Flood County Park Landscape Plan

Final Revised Environmental Impact Report/
Response to Comments Document

October 2019

Figure 5 Proposed Parking Map

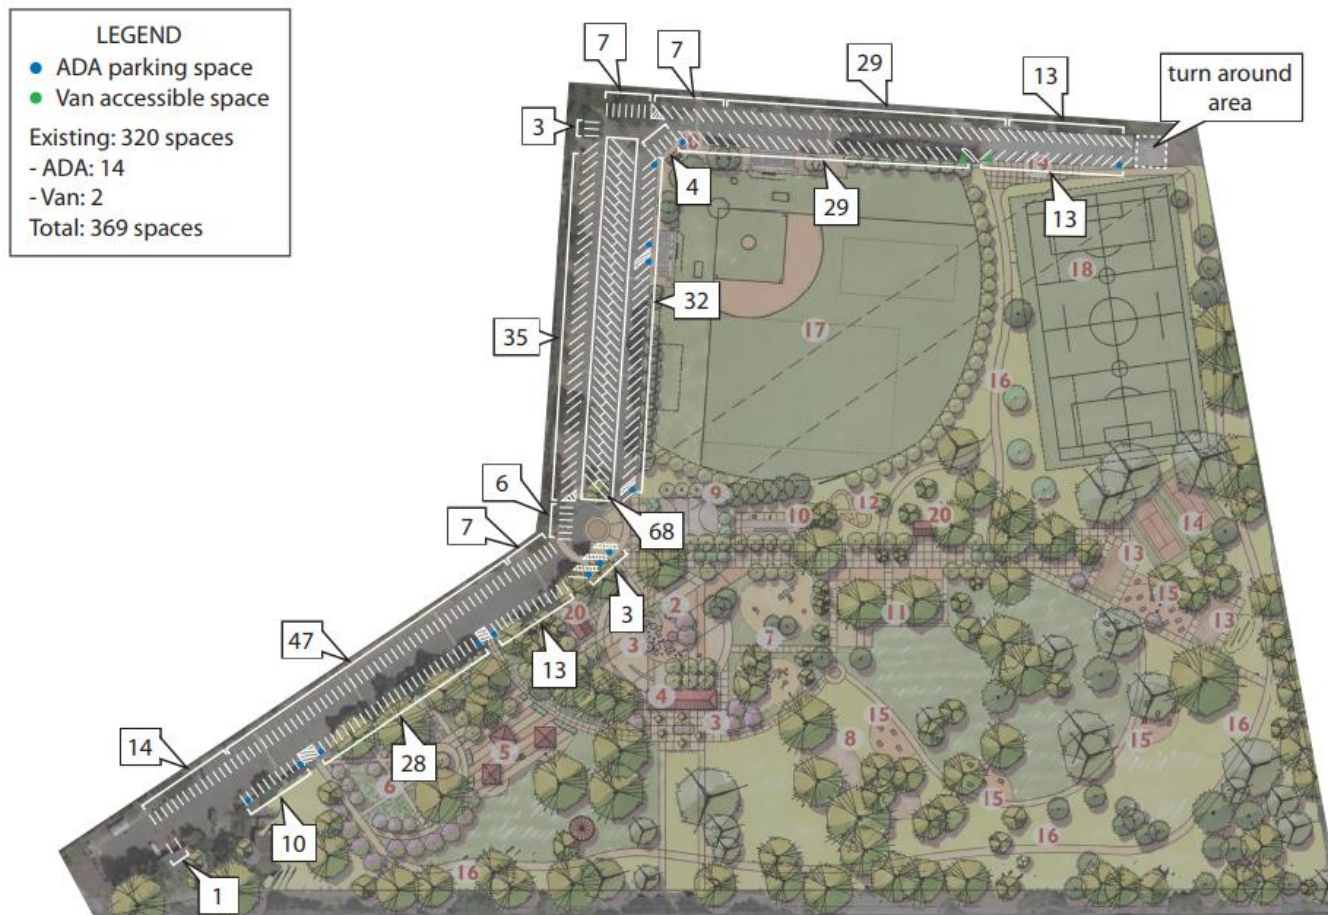
- *The Draft EIR's analysis of parking demand generated by the Landscape Plan is inadequate because it relies on inappropriate data and does not account for peak use of the park.*

A second parking count was completed at Flood Park on October 2, 2019 to confirm the number of parking spaces at Flood Park. The revised count identified a total of 320 existing parking spaces at Flood Park. As discussed on page 120 of the Draft Revised EIR the anticipated maximum parking demand during peak summer days under the Landscape Plan is 344 parking spaces. Therefore, there would be a deficient of 24 parking spaces. To account for the deficient in parking spaces the Landscape Plan has been revised to include additional 49 parking spaces at Flood Park. With the additional 49 parking spaces there would be a total of 369 parking spaces at Flood Park, which would exceed the peak parking demand by 25 parking spaces. The Final Revised EIR has been updated to include the following:

The Landscape Plan would not involve changes to parking and access, except for a new drop-off area on-site and stripping for an addition of 49 parking spaces on already paved and gravel surfaces. Flood County Park's existing vehicular access from Bay Road, via the entrance gate at the southwest corner of the park, would be retained, as would the existing asphalt parking lot on the western edge of the site. Pedestrians also would retain access to the park through entrances gaps in a chain-link fence along Bay Road and at the eastern gate from Iris Lane. An additional 26 parking spaces and a turnaround area would be added to the site of the existing pétanque court, as shown in Figure 4 and Figure 5, Proposed Parking Map. New parking stall locations have been identified throughout the site in existing paved areas and include the following: one parking stall near the existing pay station; two parking stalls in the island near the eastward turn near the ballfield; one stall in the island behind the ranger residence; one stall in the island on the south side of the eastward turn; seven stalls in the approximately 60 foot space and four stalls in the approximately 36 foot space before the pétanque court; and seven stalls by converting ADA van parking stalls to ADA car parking stalls . Therefore, an additional 23 stalls stripped outside of the pétanque court and 26 stalls stripped within the pétanque court would add a total of 49 new parking spaces at Flood Park. Please see Figure 5 for a layout of all 369 parking spaces.
